## Catwalk and Tower Engineering Bulletin

### Product Upgrade: Catwalk Cross Member Upgrade for #2 and #4 Catwalk Systems

#2 Catwalk Cross Member Upgrade

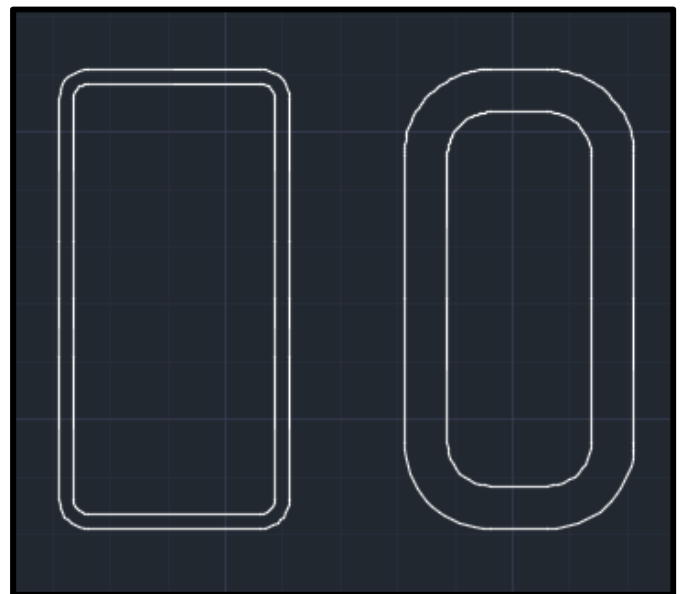
Chief Agri Industrial is pleased to announce that the cross members for the #2 and #4 catwalk systems have been upgraded. The new cross members allow for conveyors to be supported every 10 feet which is every third cross member. Prior to this, depending on the weight of the conveyor, supports needed to be placed on every cross member or every other cross member. Supporting the conveyors every 10 feet is consistent with what is recommend by Chief for drag conveyors as well as other manufacturers. Customers also prefer conveyors supported every 10' so that they can change the bottoms of the conveyors without removing supports. Catwalk package part numbers remain the same as they were before.
